# SERVICE No. 301A BULLETIN

Piper Aircraft Corporation

- Subject: Reissued Airplane Flight Manual and New Placards  
(Reference FAA Airworthiness Directive for PA-30 dated  
November 5, 1969)
- Models Affected: PA-30 Twin Comanche

- Serial Numbers Affected: 30-1 to 30-2000 incl.
- Compliance Time: Prior to next flight.
- Purpose:
- I. To rescind Piper Service Bulletin No. 301 dated August 29, 1969 and telegrams dated September 19, 1969 and September 23, 1969 to all Piper Distributors and Flight Schools.

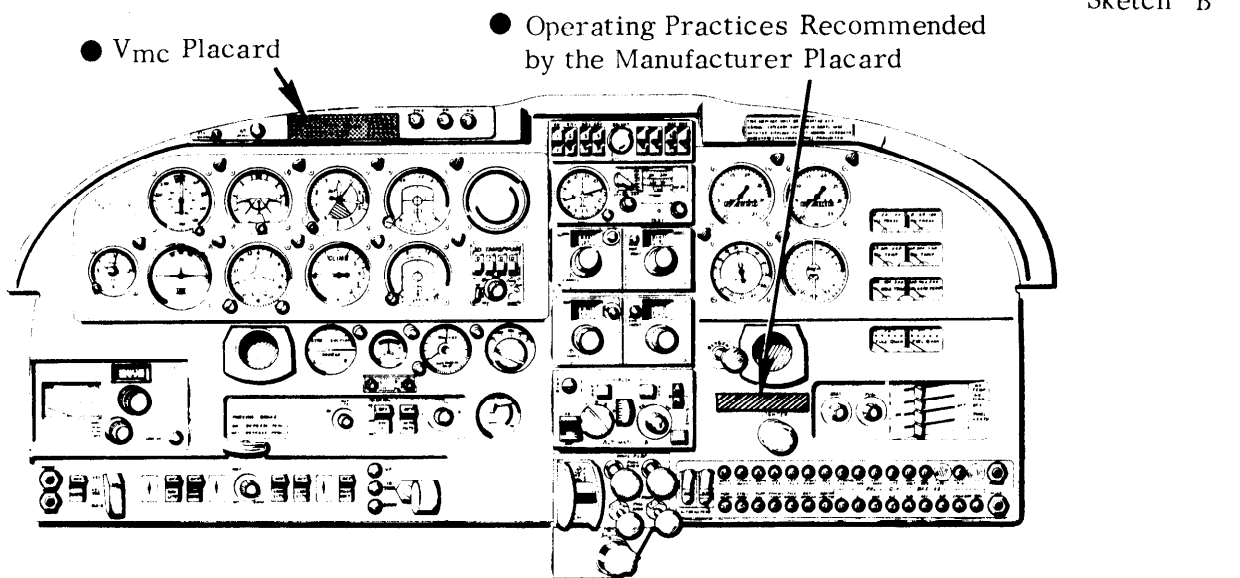
- Instructions:
- I. Aircraft serial numbers 30-1 to 30-1716, 30-1718 to 30-1744 incl.:
    - A. Remove or cover existing minimum single engine control speed placard and install new Vmc placard, per sketch A, page 3 of this bulletin.

- B. Install new operating practices recommended by the manufacturer placard, located as denoted on Sketch A, page 3 of this bulletin.
    - C. Replace existing Section 1, Airplane Flight Manual Report No. 1269 with reissued Section 1 (reissue date 11/15/69), Airplane Flight Manual Report No. 1269, supplied with Vmc Placard Installation Kit part number 760 354 (reference Material Required, below).

- A. Remove or cover existing minimum single engine control speed placard; install new Vmc placard per Sketch B, page 3 of this bulletin.
  - B. Install new operating practices recommended by the manufacturer placard, located as denoted on Sketch B, page 3 of this bulletin.
  - C. Replace existing Section 1, Airplane Flight Manual Report No. 1515 with reissued Section 1 (reissue date 11/15/69), Airplane Flight Manual Report No. 1515, supplied with Vmc Placard Installation Kit part number 760 355 (reference Material Required, below).
- III. Page 7a (revised 6/30/69) of Weight and Balance Section of Airplane Flight Manual Report Nos. 1269 and 1515, previously supplied with Service Bulletin No. 301, dated August 29, 1969 is not to be discarded, but must remain with the Airplane Flight Manual.

- II. To provide additional safety in case of single engine operation by increasing Vmc to 90 MPH CAS for all flap settings.
  - III. To provide additional recommended safe operating practices.
